MY2 Monitoring Report

Owen Farms Mitigation Site
Transylvania County, NC

Re: MY2 Monitoring Report Comments
Owen Farms Stream and Wetland Mitigation Site
French Broad River Basin; CU# 06010105 – Transylvania County
DMS Project ID No. 100064
Contract No. 7532
SAW-2018-01165

Response to DMS Comments

Figure 8.3: W3 Groundwater Gauge Data

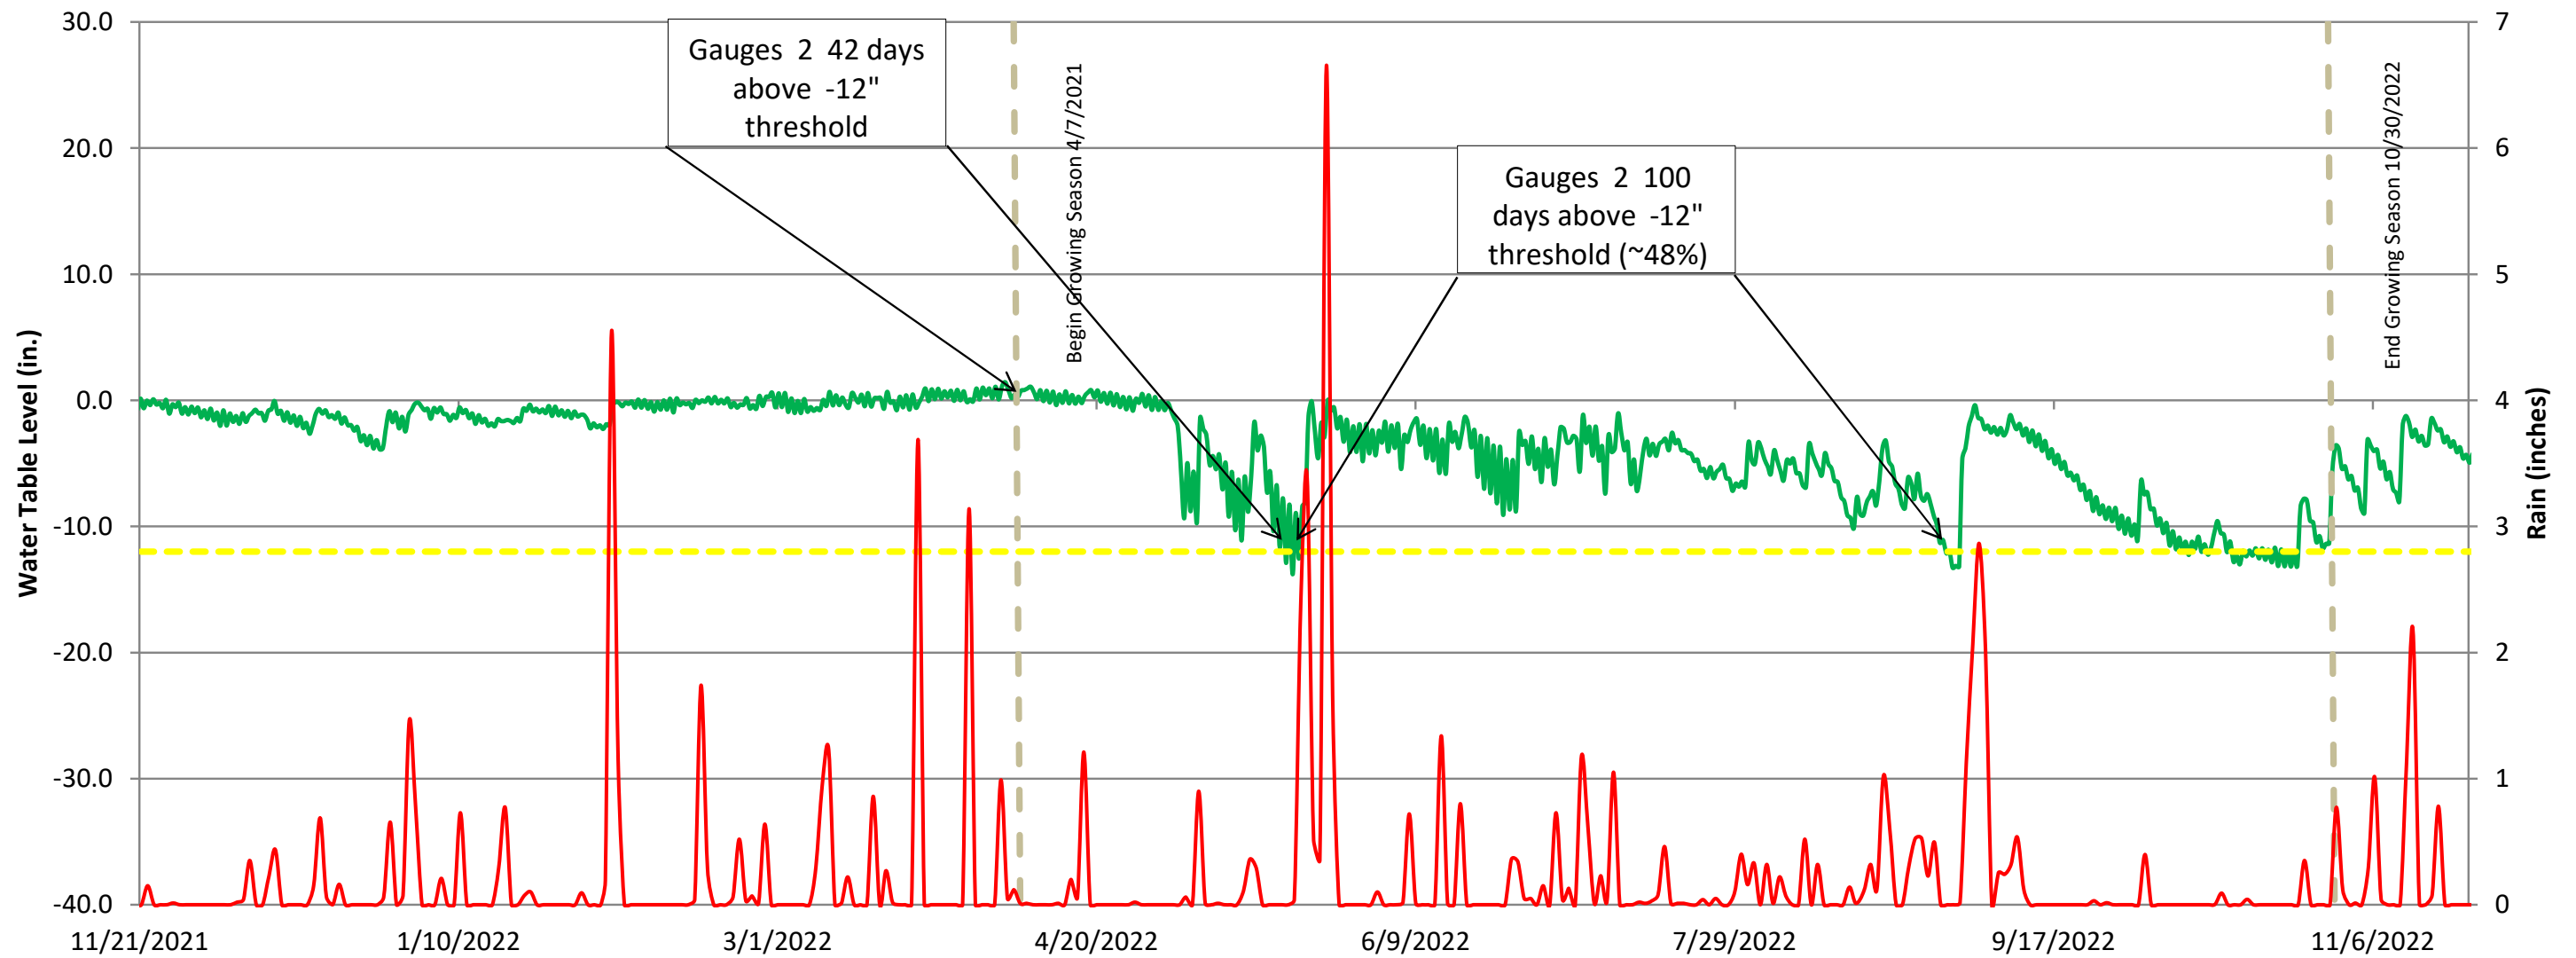
18: Figure 8.1- 8.6: Groundwater gauge data graphs: Please update the graphs to include all of the data from the MY2 (2022) growing season. Please also update each graph to include the percentage of the growing season based on the growing season dates established. *Data has been updated. Percentages were added to graphs and can be viewed in Table 14: Wetland Hydrology Summary.*
